DESCRIPTIVE REPORT

Registry No. H10980

General Locality Shelikof Strait

Project OPR-P164-RA

Figure 2. H10980 Junction Surveys.

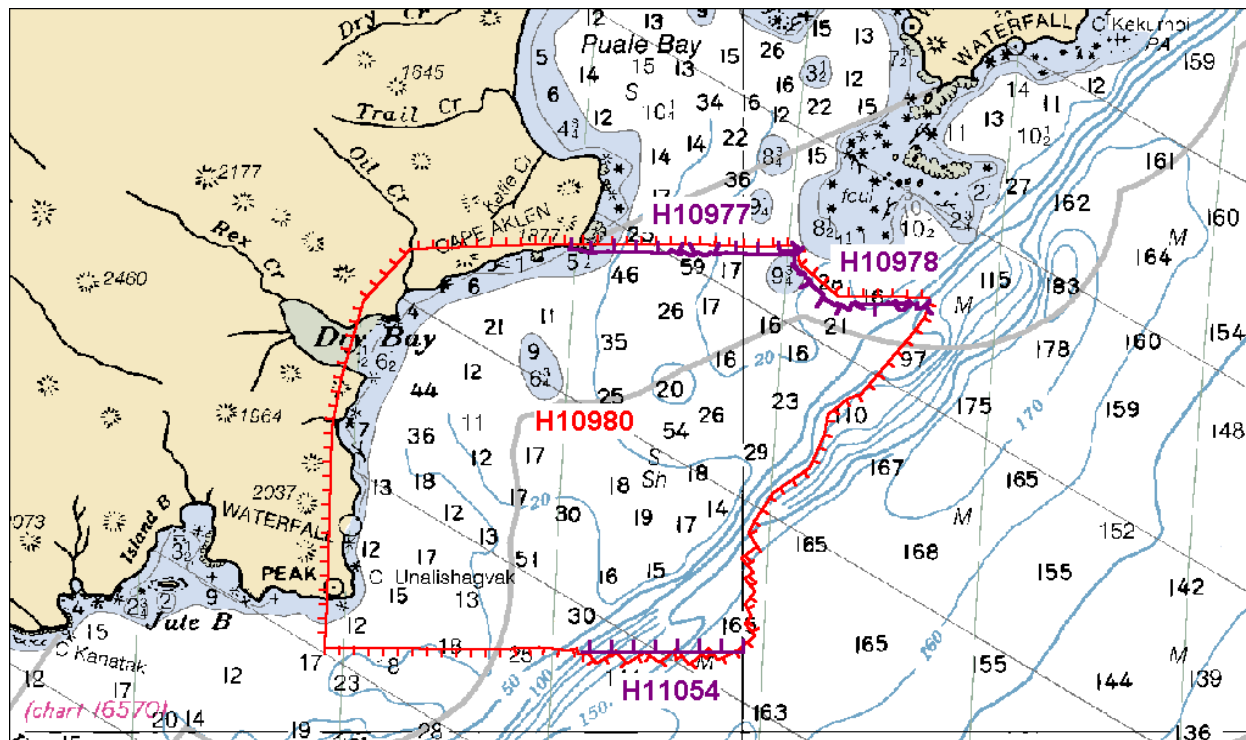
Registry #⁷	Scale	Date	Junction side
H10978	1:10,000	2001	Northeast
H10977	1:20,000	2000	North
H11054	1:40,000	2001	South

Survey H10978 junctions well with this survey, with differences generally one fathom or less.⁸

Survey H10977 junctions well with this survey, with differences generally one fathom or less.⁹

At the time of this report, data processing for survey H11054 was not completed. Comparisons of the junction with this survey will be discussed in the Descriptive Report for H11054.¹⁰

⁶ PHB Revision - The junctions with H10977 and H10183 were not formally completed since these surveys were processed previously. A comparison of soundings between the surveys generally reveals good agreement. Depth curves on the present survey have been drawn in consideration of depths depicted on the adjoining surveys. An “Adjoins” note has been added to the smooth sheet.

The junction with surveys H-10978 and H11054 are complete. A “Joins” note has been added to the smooth sheet where applicable. Agreement is generally good between these junctional surveys and H10980. Some soundings from H10978 have been transferred within the common area to better delineate the bottom configuration and to support depth curves common to both surveys.

⁷ PHB Revision - Add survey H10183 1:10,000 1985 Southwest
